**AGENDA**  
**Molalla Planning Commission**  
**6:30 PM, March 2, 2022**

- SDR07-2021 – 1000 W Main St (60-unit apartment complex)

The applicant/owner, Green Light -- Home First LLC is requesting approval of a Type III Site Design Review application for an apartment complex that will provide 60 affordable housing units. The subject property is located at 1000 W Main Street, contains approximately 2.95 acres, and is identified by the Clackamas County Assessor as Tax Lot 1500 of Tax Map 52E08C. As indicated by the attached Preliminary Development Plans, the applicant will remove an existing single-family dwelling, barn and accessory structures with the proposed development (see Exhibit 4).

DRAWING  
**C2.0**  
 JOB NUMBER  
**3312.0000.0**

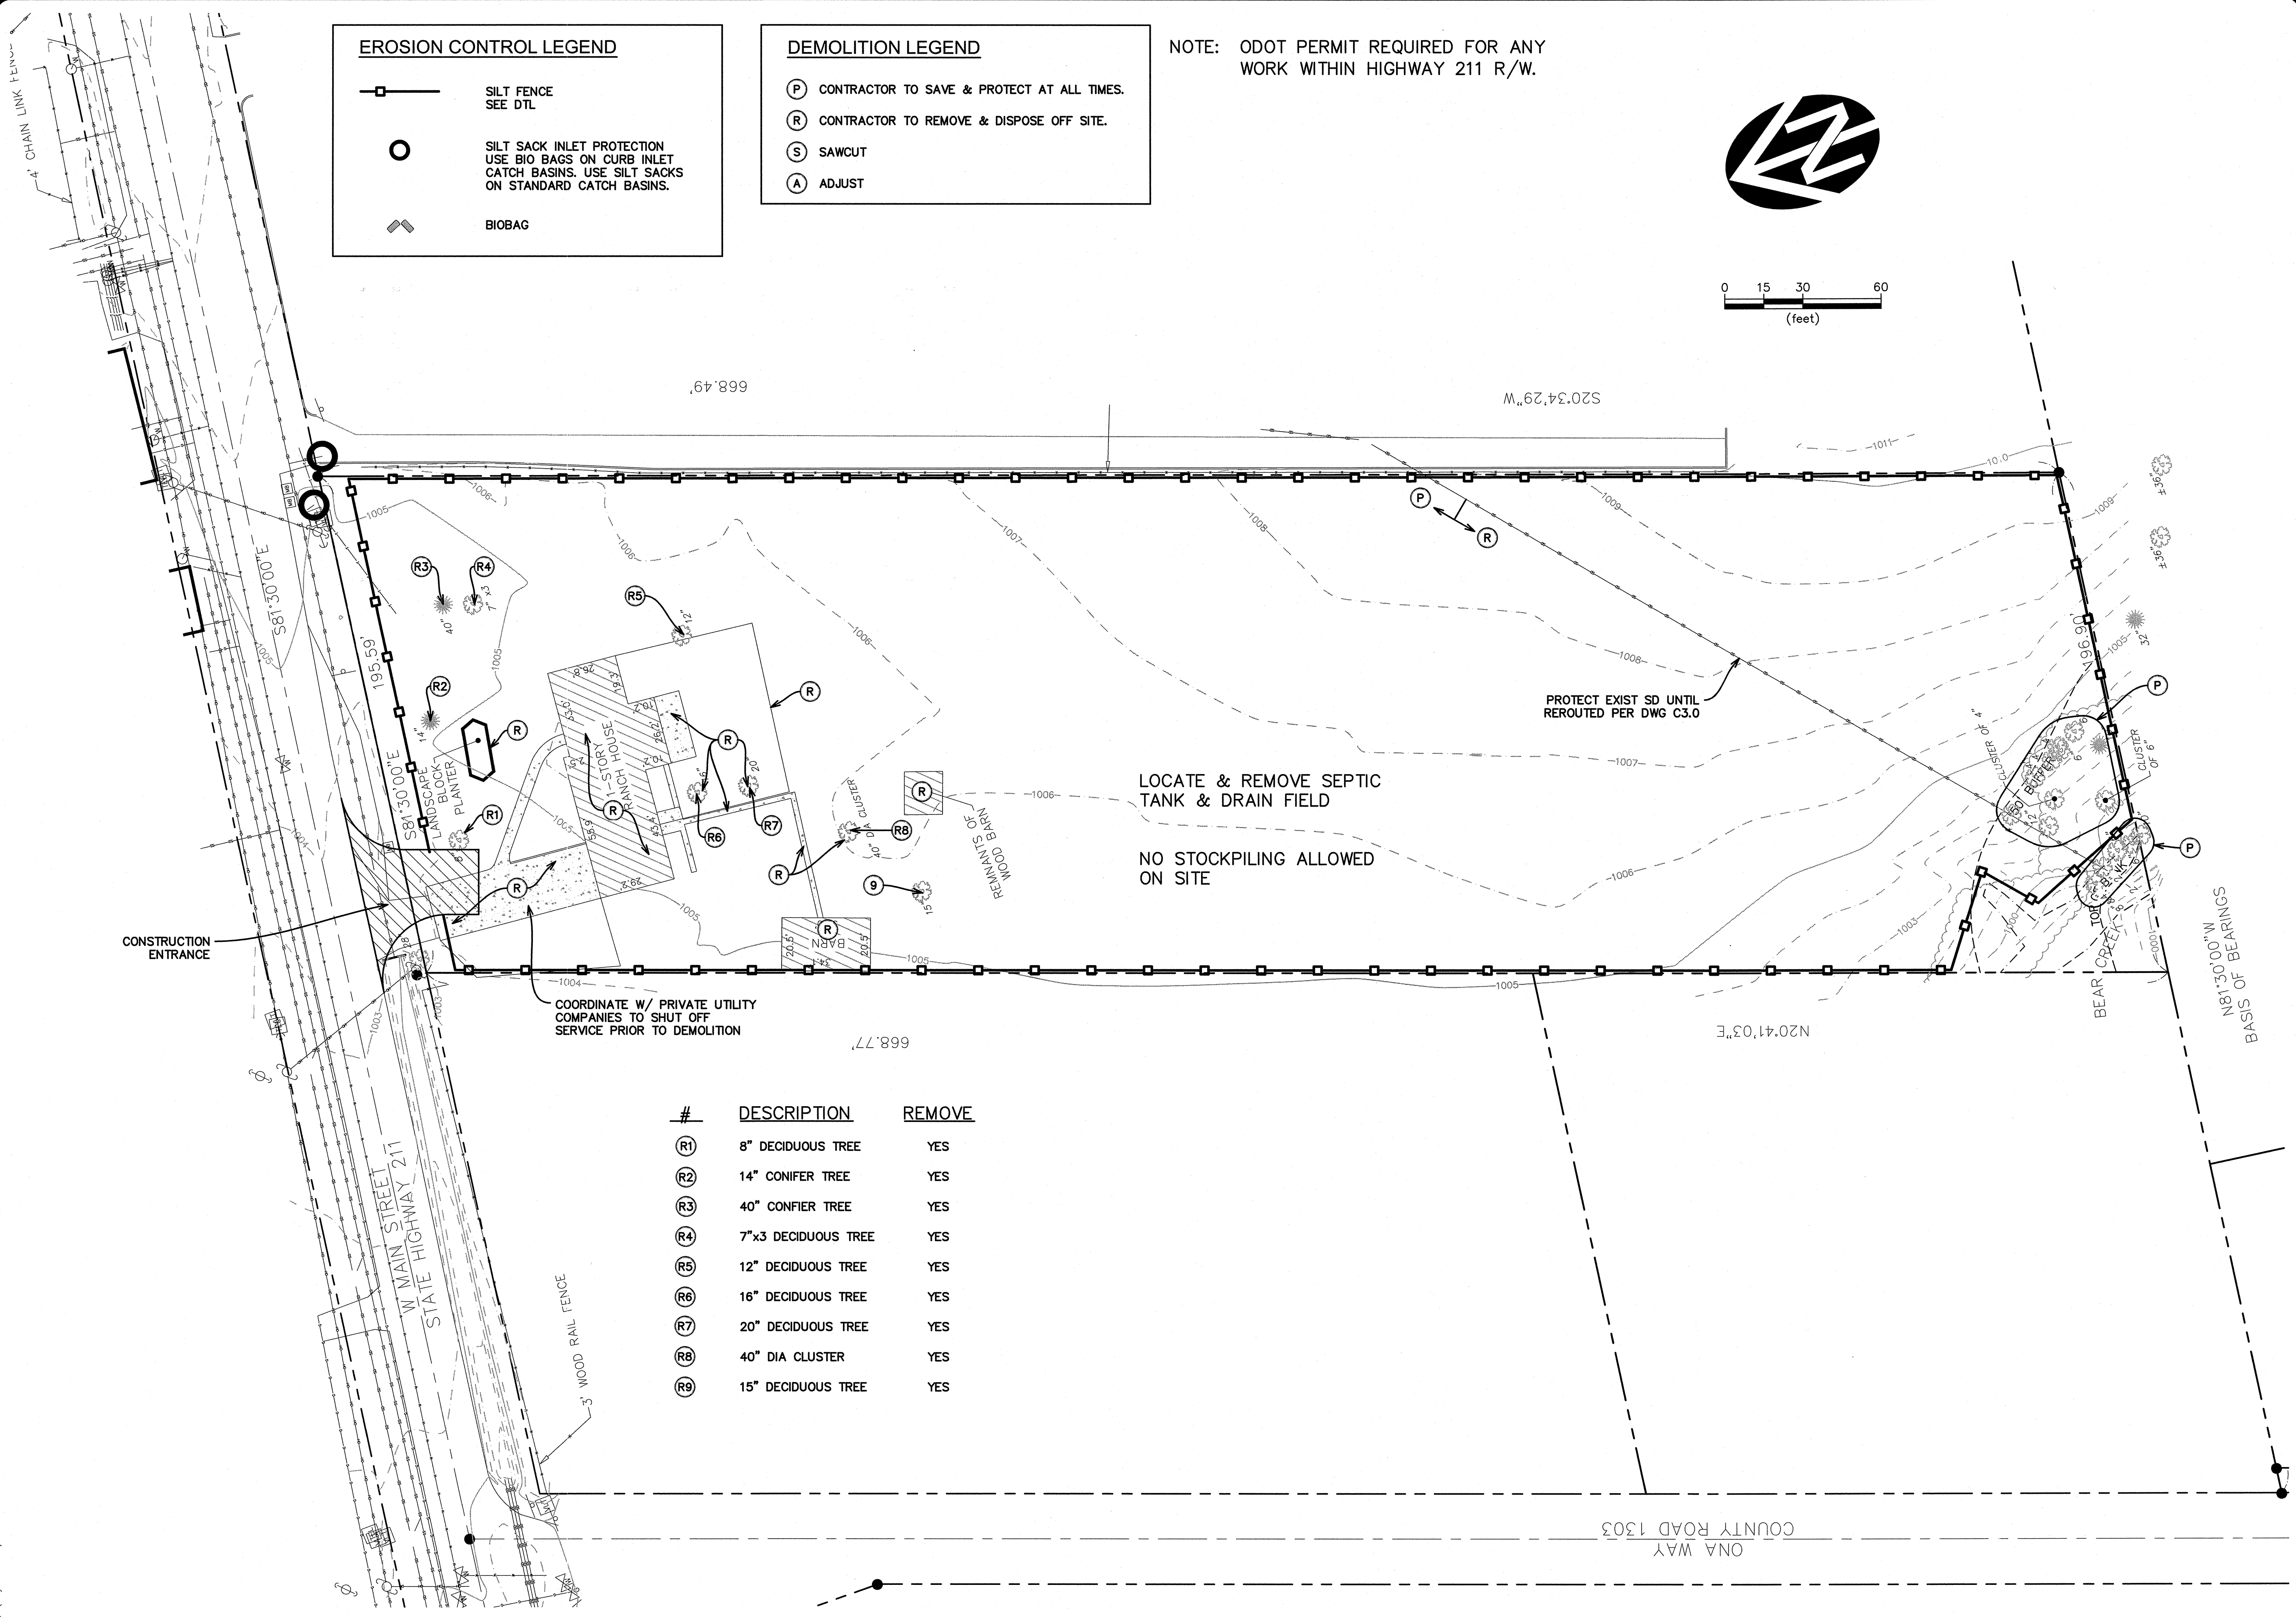
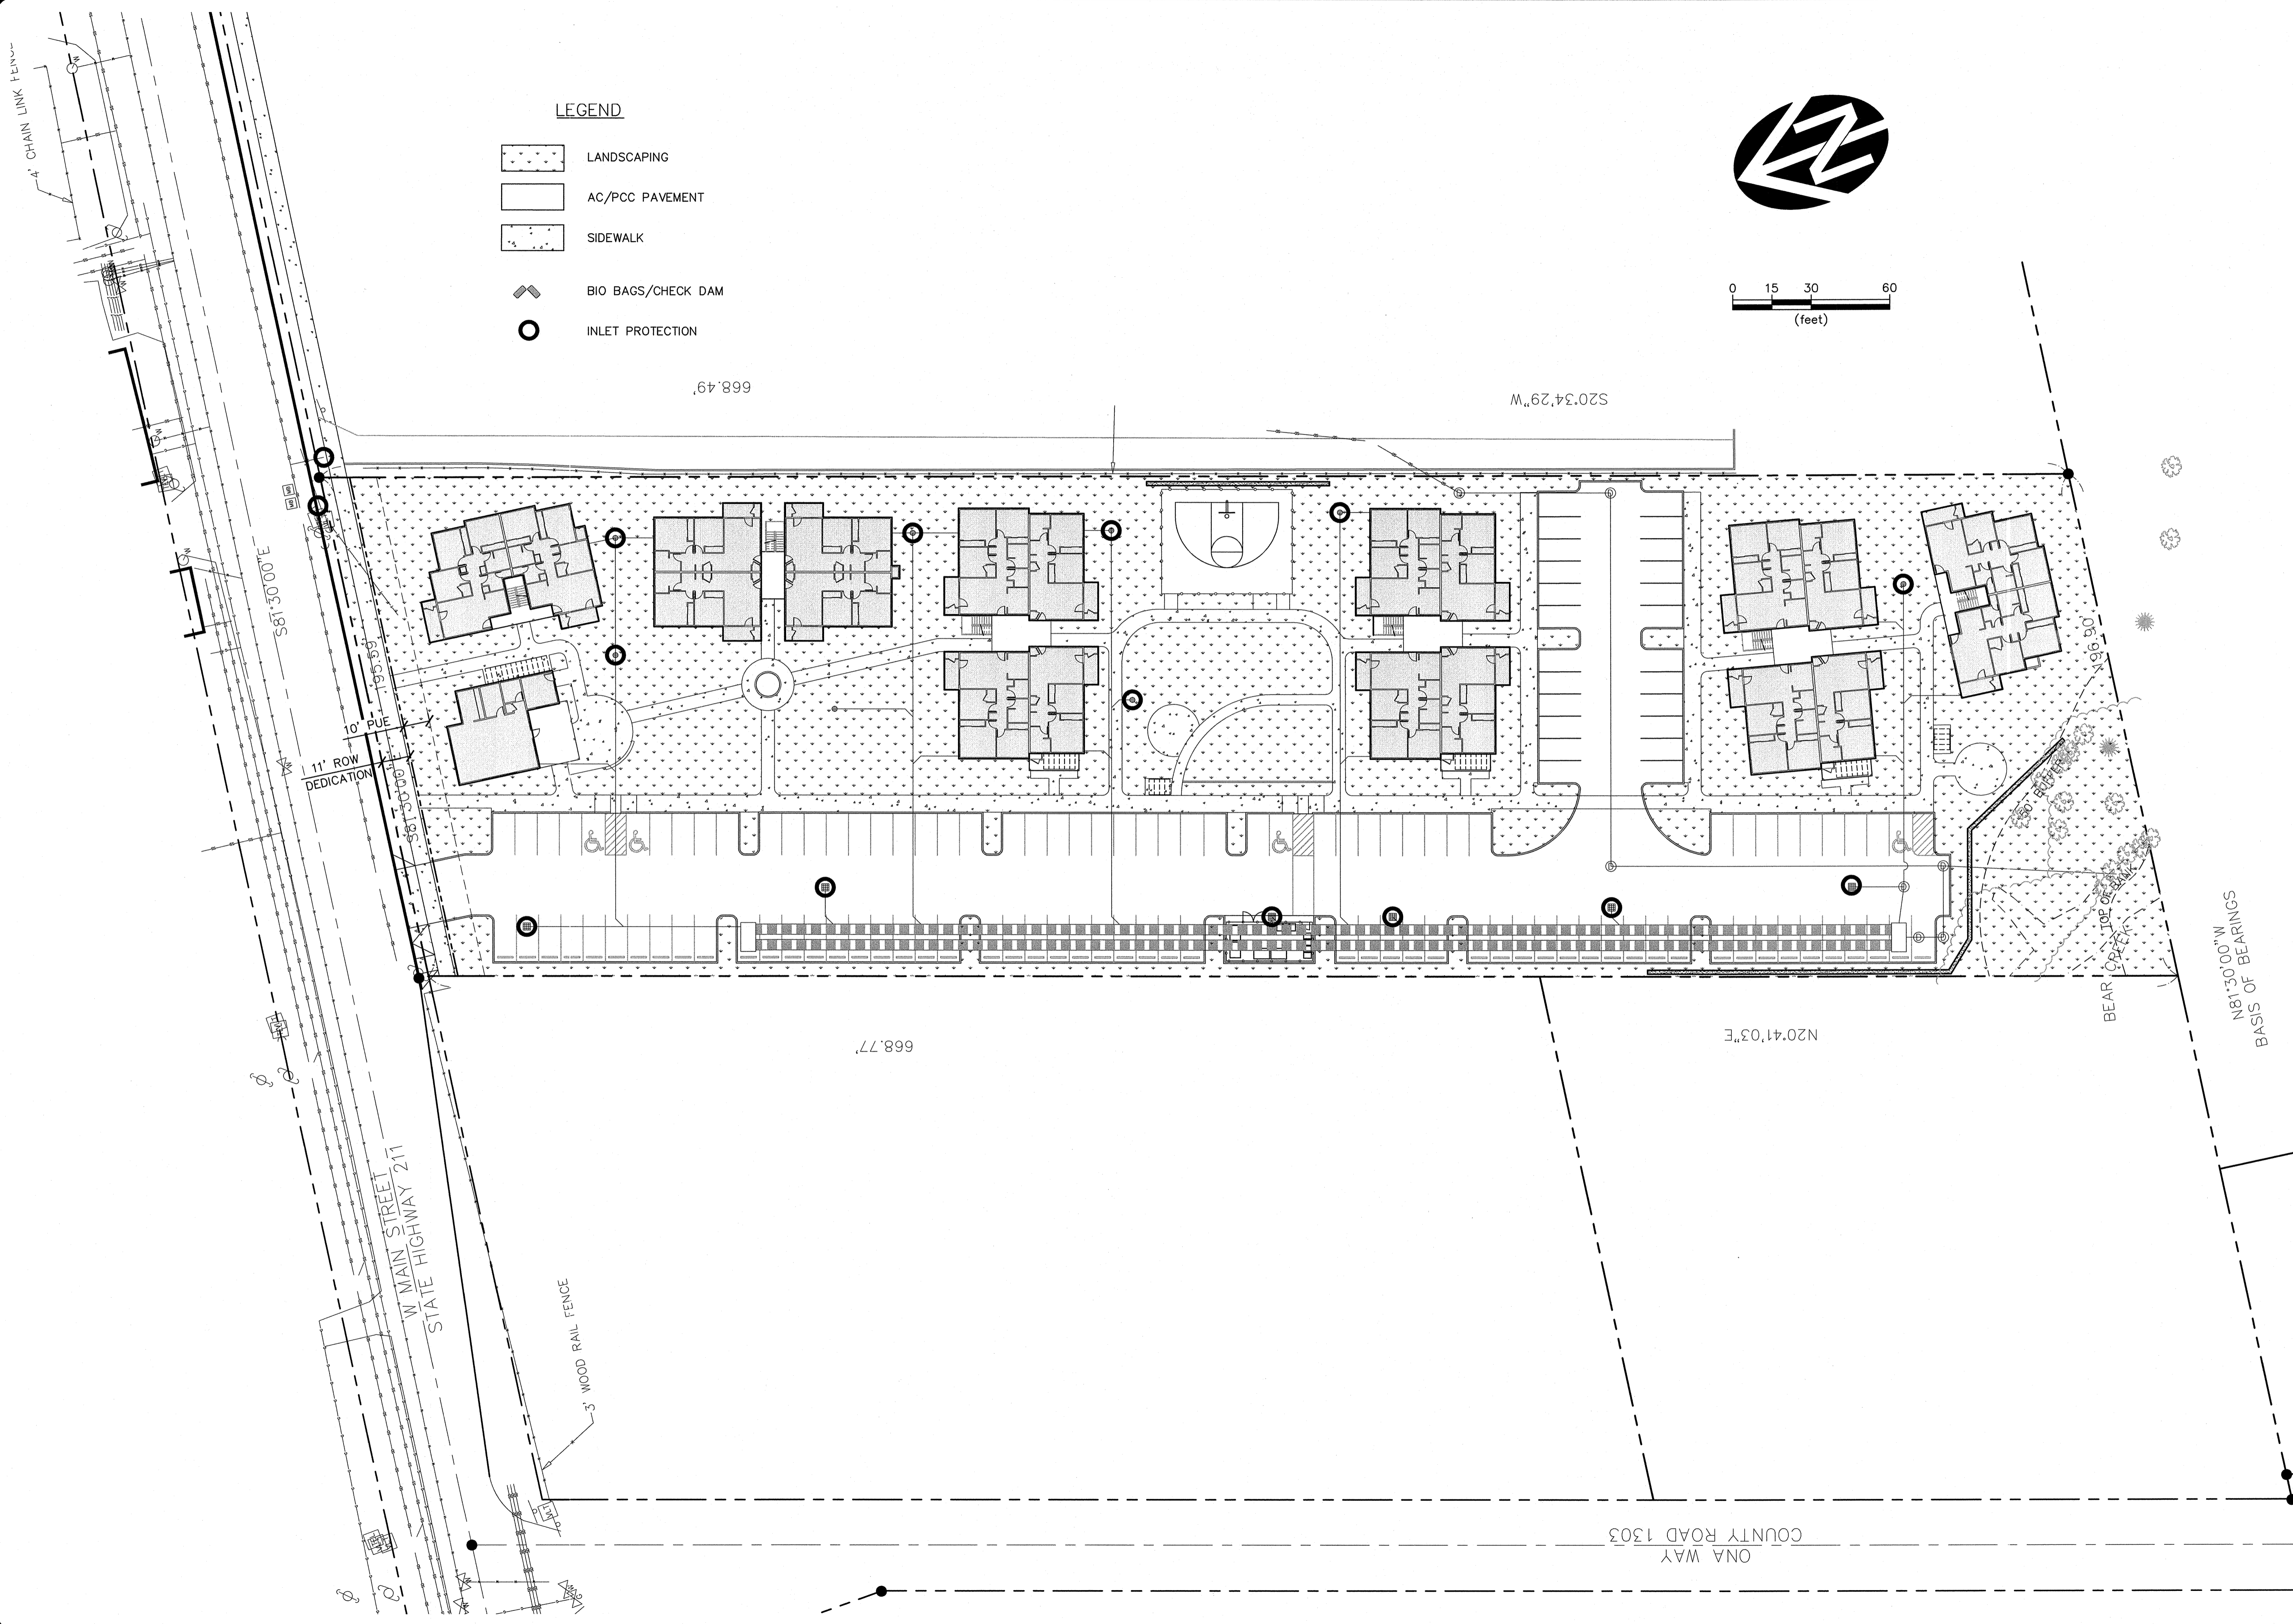
The Existing Conditions Plan indicates that 9 trees are proposed for removal to accommodate development of the apartment complex (see Exhibit 4). Where feasible, the applicant is proposing to retain existing trees on the subject site, including within the 50-ft. wide riparian area along Bear Creek.

SITE LIGHTING PLAN

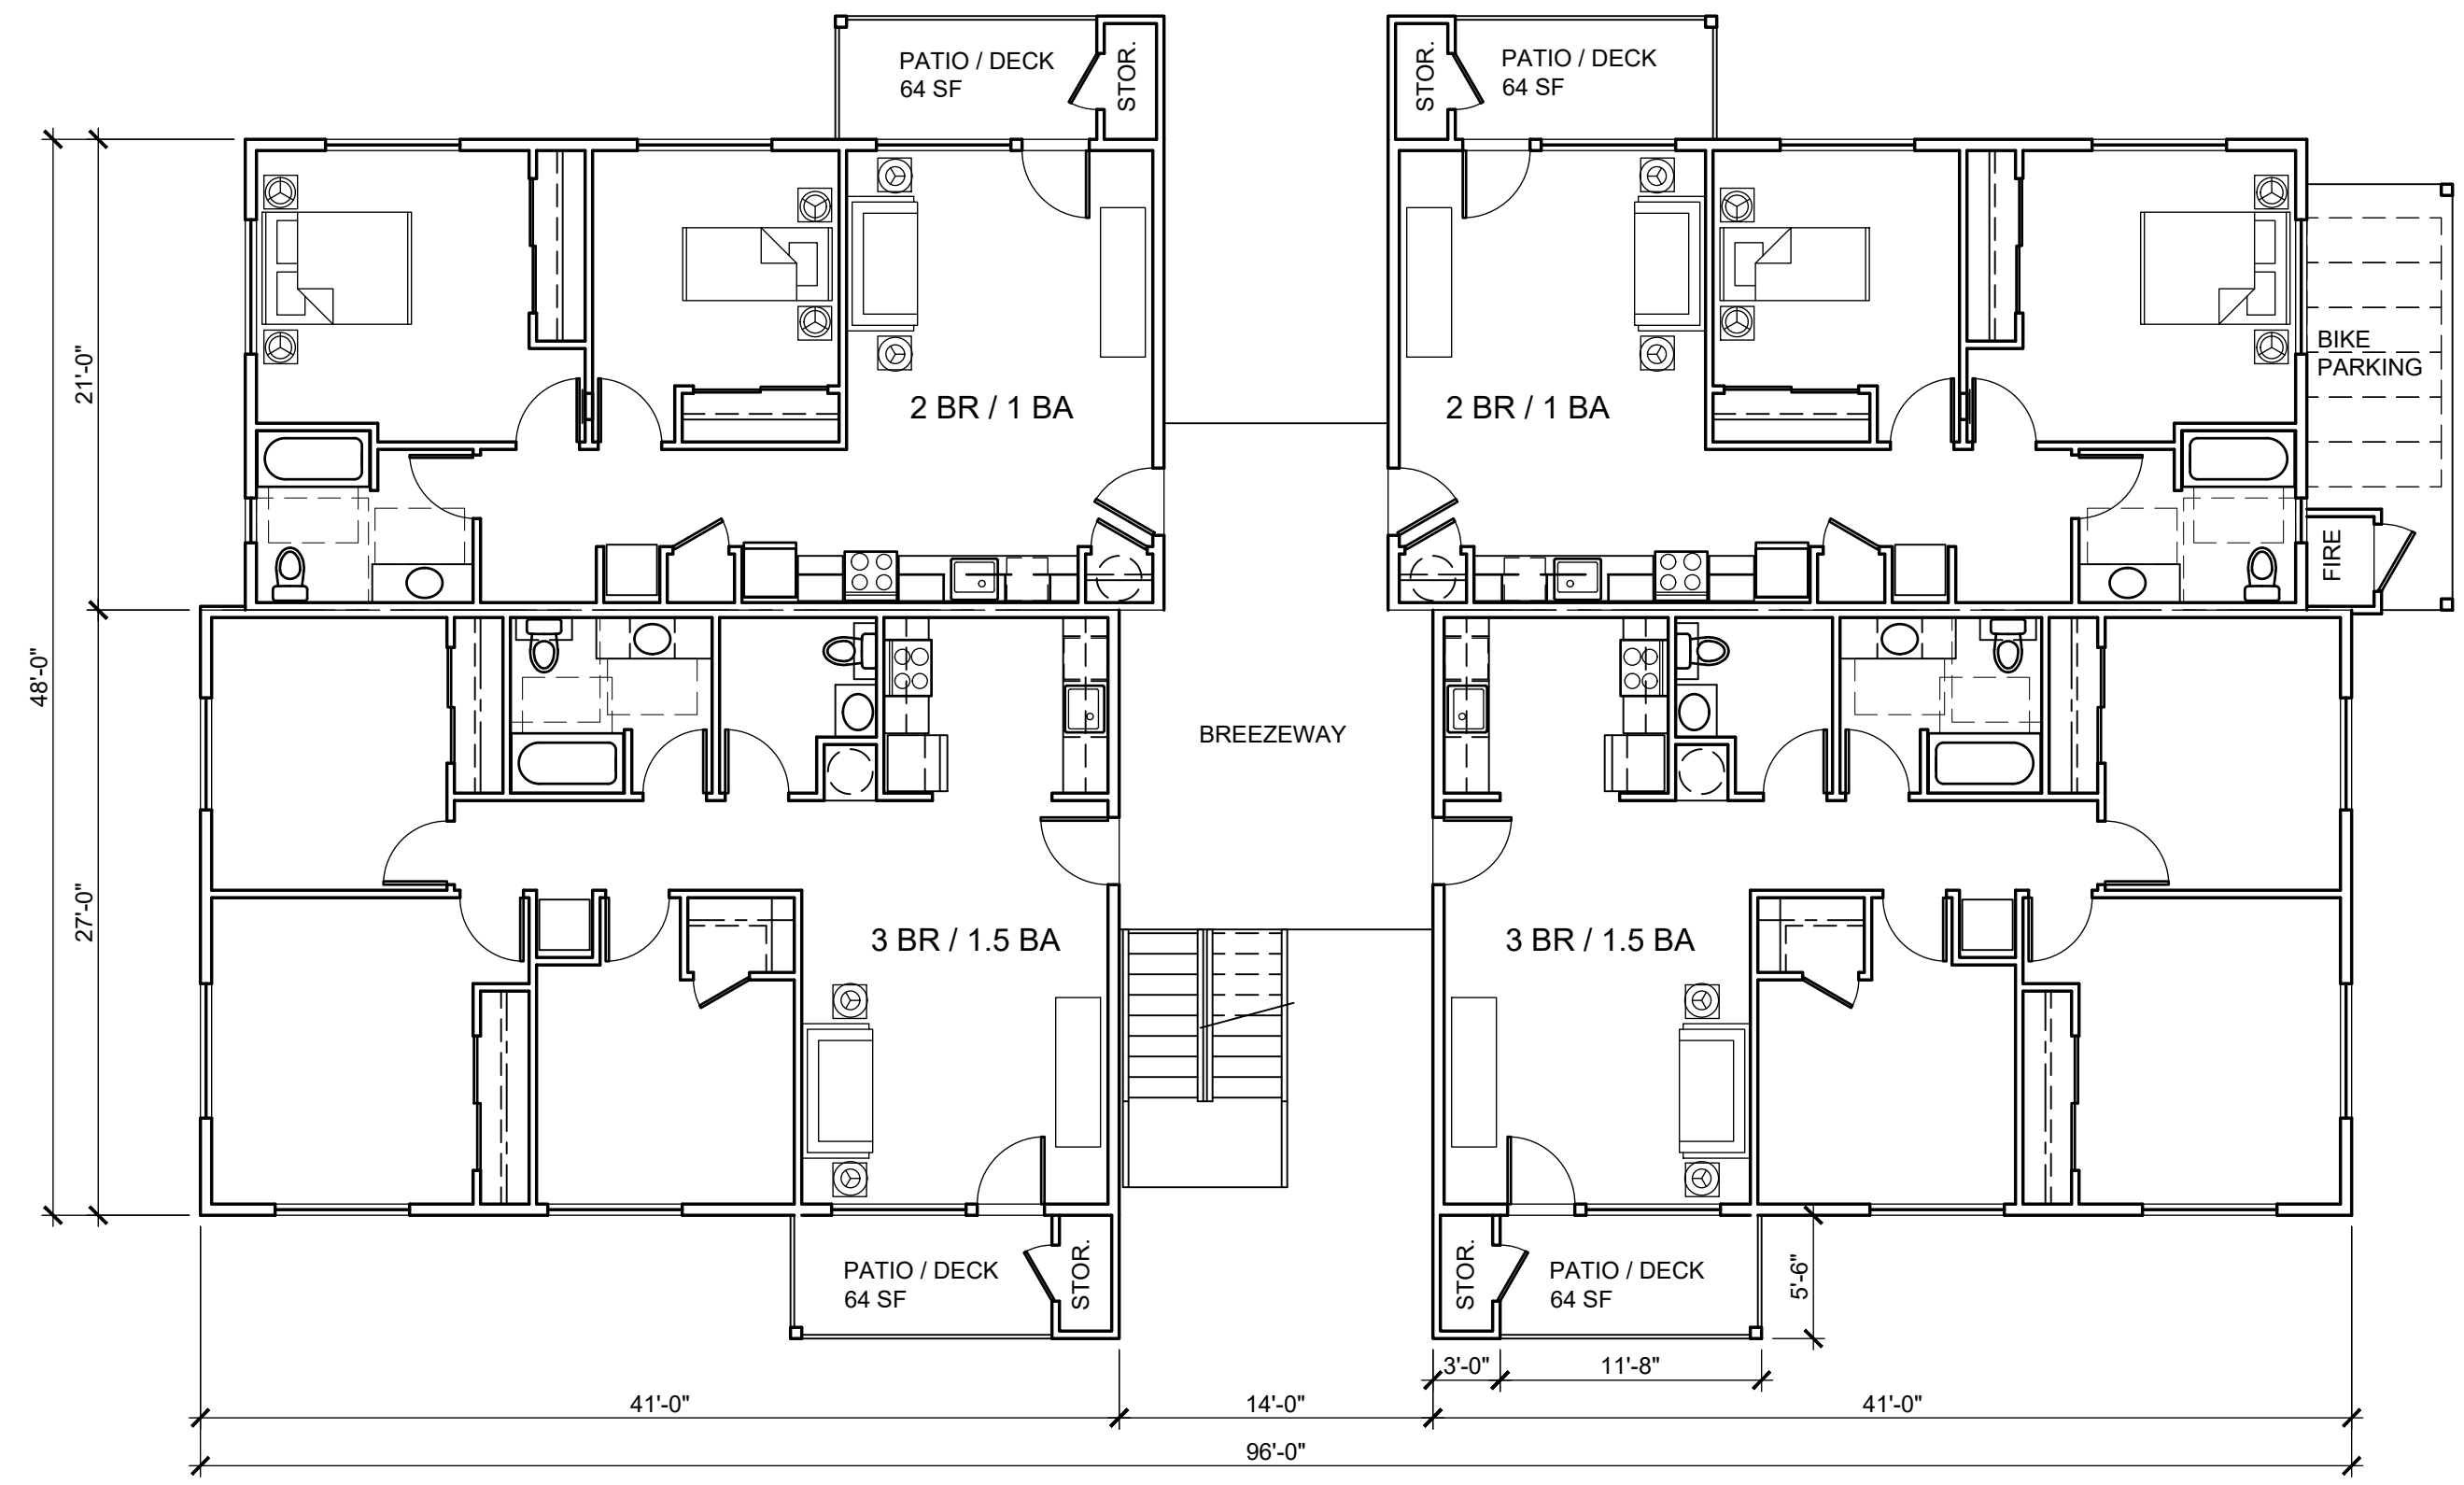
The attached Site Lighting Plan demonstrates that all of the above lighting standards have been met (see Exhibit 4).
